**Re: CLEARY BROS. ALBION PARK QUARRY – STAGES 5 & 6 MODIFICATION
LEC CONSENT NO. 10639 OF 2005 MOD 3
SUPPLEMENTARY RESPONSE TO MATTERS RAISED IN SUBMISSIONS**

I refer to the NSW Department of Planning & Environment (DPE) correspondence dated 13th October 2016 and associated Agency/public submissions, requesting the preparation and submission of a supplementary report responding to the matters raised in relation to the Environmental Assessment provided for the above-mentioned Modification 3. These submissions have been reviewed by representatives of Cleary Bros (the proponent) and their consultants, with the following responses provided for the DPE's consideration in this instance.

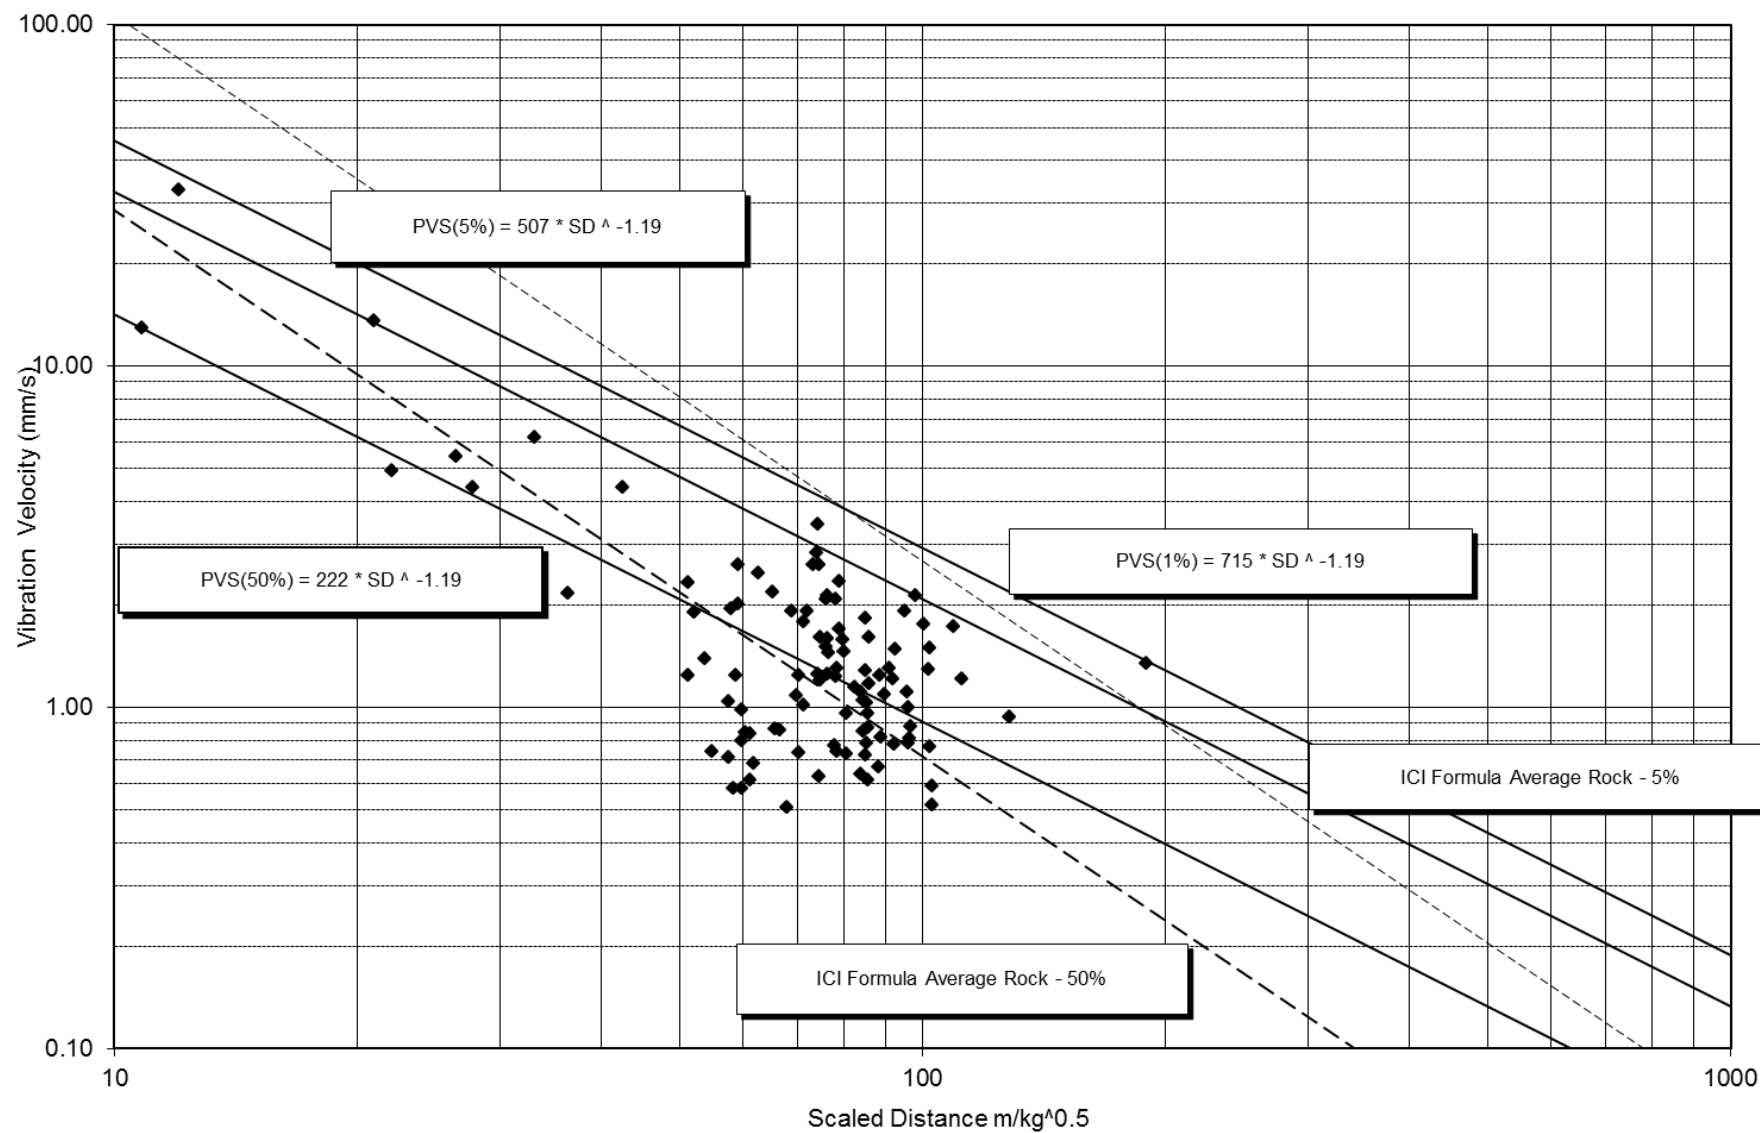
- b. The DPE submission raised concerns that the noise level contour plan in Appendix C of the Noise and Blasting Assessment by SLR was not clear, with poor contrast between the different contours. This plan has now been amended to improve the contrast and is included in updated report attached as *Appendix 2* of this supplementary response.
